**RE: 500 Harvard Street, Brookline, MA
Response to Parking Peer Review**

In response to the comments provided by Walker Consultants in their letter titled "PARKING PEER REVIEW – 500 HARVARD STREET" and dated June 17, 2020, CUBE 3 (C3) has the following responses:

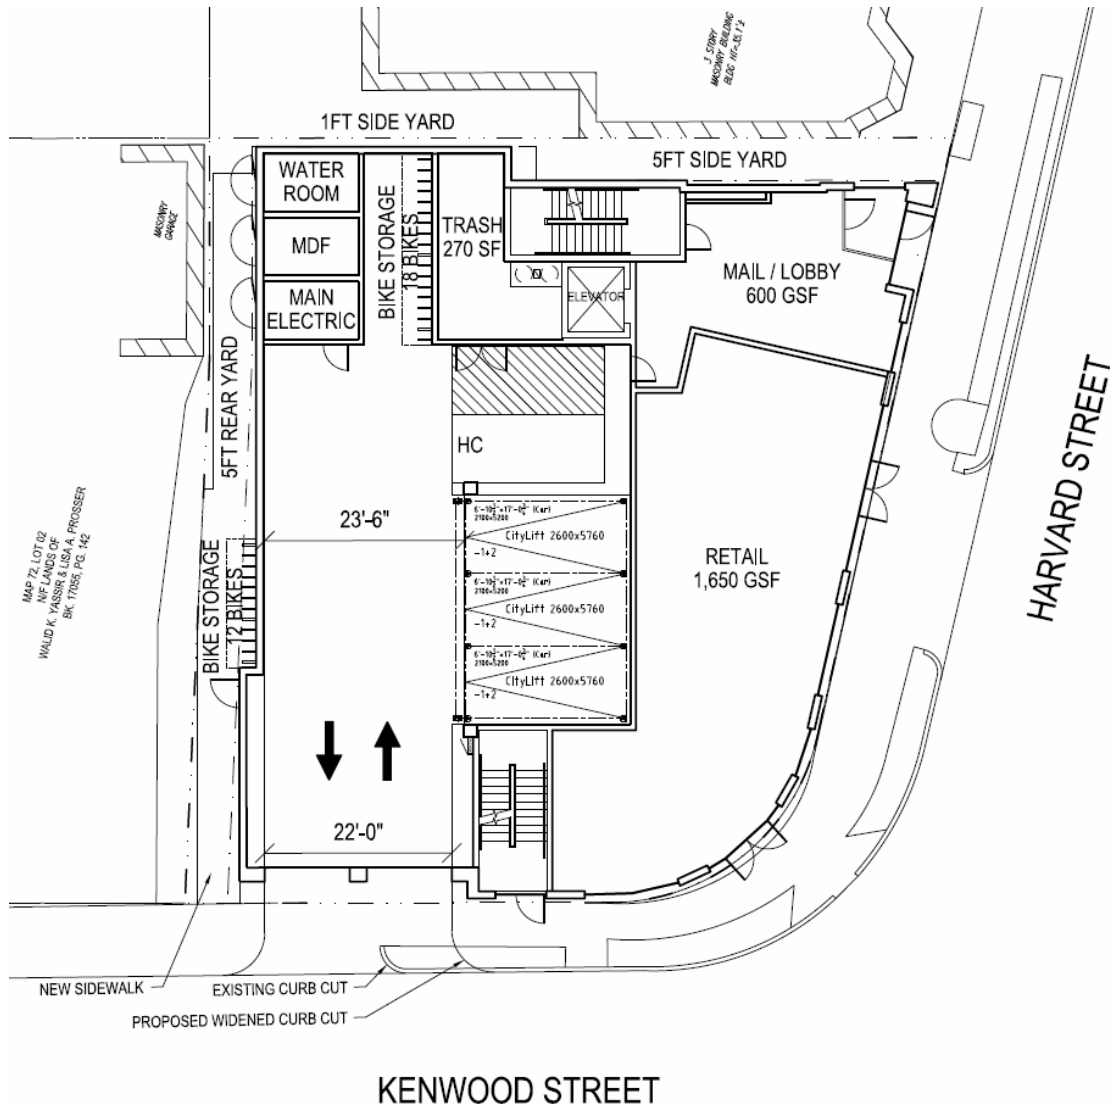
WC Comment 8: *"The parking spaces and drive aisle appear to comply with Zoning but should be confirmed.*

- (a) The spaces appear to be 9-ft (based on scaling) and the drive aisle is 22-ft wide, but it is unclear if the actual parking spaces is less than that if the puzzle parking system encroaches on that dimension.*
- (b) If the spaces are reduced to 8.5-ft wide, Zoning requires the drive aisle to be 23-ft wide and this layout would not comply.*
- (c) Note that Zoning does not explicitly address mechanical parking; these requirements are based on typical self-park conditions."*

C3 Response: The Development Team has engaged with CityLift, the manufacturer of the Puzzle system to confirm exact dimensions of the system anticipated in this project. The below plan shows the updates based on the system. The parking spaces in the Puzzle system are 8'-6" wide and when the gate is up so that the vehicle can maneuver, the drive aisle will be approximately 23'-6" wide. The driveway outside of this area is anticipated to be 22' wide. We believe this layout to be compliant with the Zoning.
